Track 1 Decision Documentation Package
Waste Area Group
Operable Unit 6

Site CPP-47
Pilot Plant Storage Area West of CPP-620

NO FURTHER ACTION DETERMINATION

SITE DESCRIPTION: PILOT PLANT STORAGE AREA WEST OF CPP-620

FIGURE 3.
LAND DISPOSAL UNIT CPP-47
PILOT PLANT STORAGE AREA
EG & G/CPP-47/1D

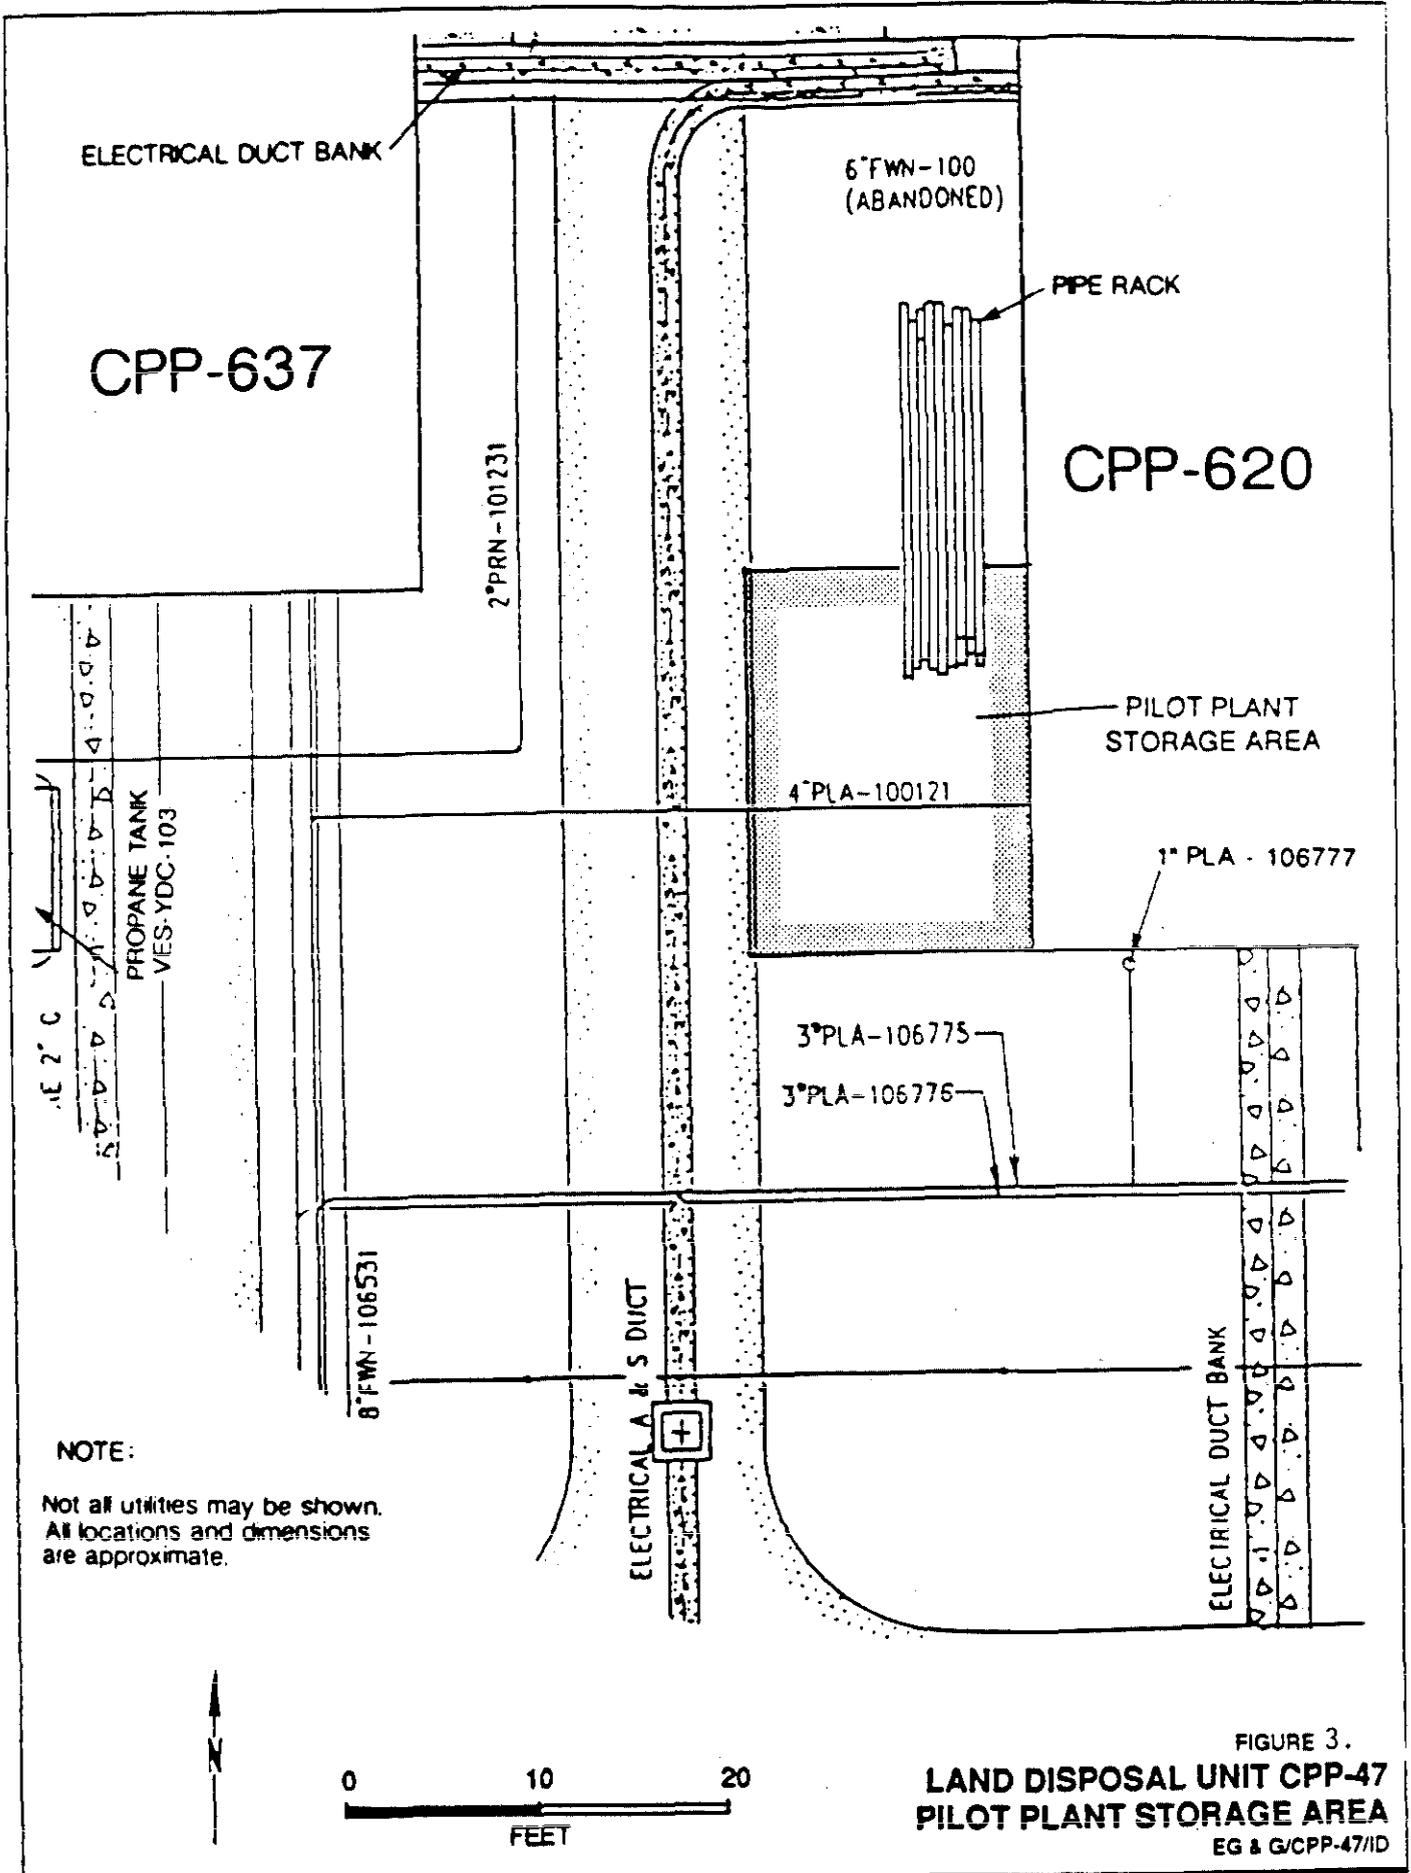
Associated HF spill (\approx 2 gal) from drum storage area (1-3 drums). Spill occurred in about 1984. Caption for site map CPP-47 is in error and should not be "Mercury Contamination" but "HF contamination" Doe Williams 9/14/92 personal communication. Maximum soil concn. conc. of "F" under CoCA Closure plan is 240 ppm with no road contamin. found above background during site investigations. Based on conservative risk evaluations, small size of the identified site, no further action is warranted based on information supplied in this report
